**RE: Guardian Storage- Juan Tabo
4909 Juan Tabo NE
Conceptual Grading and Drainage Plan Stamp Date: 12/20/19
Hydrology File: F21D081**

Based on the submittal received on 12/19/19, the Conceptual Grading and Drainage Plan is approved for Site Plan for Building Permit.

RE: Guardian Storage – Juan Tabo Conceptual G&D Resubmittal (Hydrology File F21D081)

RESPEC requests review of the revised Conceptual Grading & Drainage Plan for the proposed Guardian Storage Development on Juan Tabo and Osuna. The updated plan contains revisions based on review comments provided on November 18, 2019. The review comments have been addressed by the following:

1 PIPE PENETRATION
SCALE: NTS

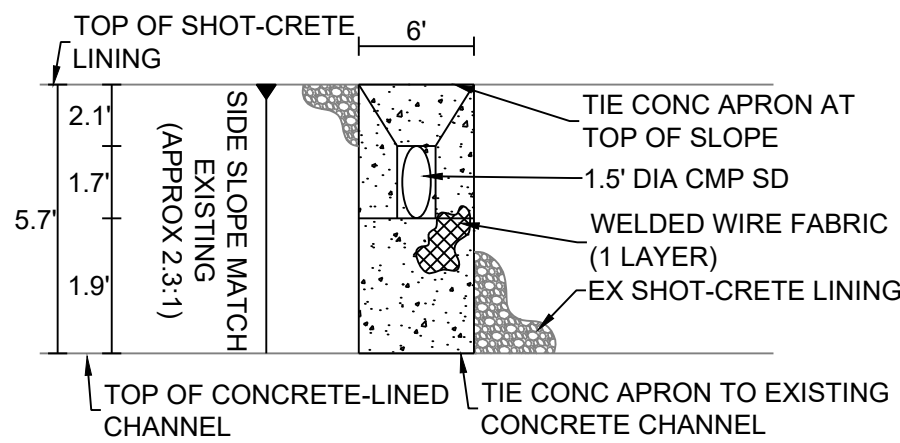
3. The discharge to Bear Canyon Arroyo shall be by City Work Order using an RCP pipe penetration into the standard concrete portion of the channel, per AMAFCA Standard Detail 103 or 104. This work needs to be included on the infrastructure list.
Per our phone conversation, a public work order will be established for the pipe penetration but will not be into the concrete portion of the channel. Instead, the proposed outfall will penetrate the existing shotcrete portion of the channel and a concrete rundown apron will be installed to tie to the top of the concrete channel. The design details for this connection will be provided in the public work order. Items for these improvements will be included in the infrastructure list.
